INITIAL FIRE SAFETY INSPECTION REPORT

ESPRIT APPARELS LTD.

RSC ID: 26401

Date: 20-October-2025

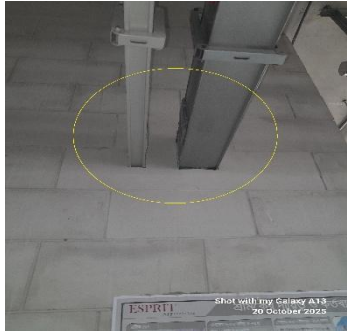
F-10	Means of Egress	Uneven path of travel was observed in the exit discharge path due to construction purposes. Location(s): North side (Building-1).	Remove unnecessary items and level exit path to the public way. Means of egress shall be maintained continuously free and clear of all obstructions	Within 3 Months
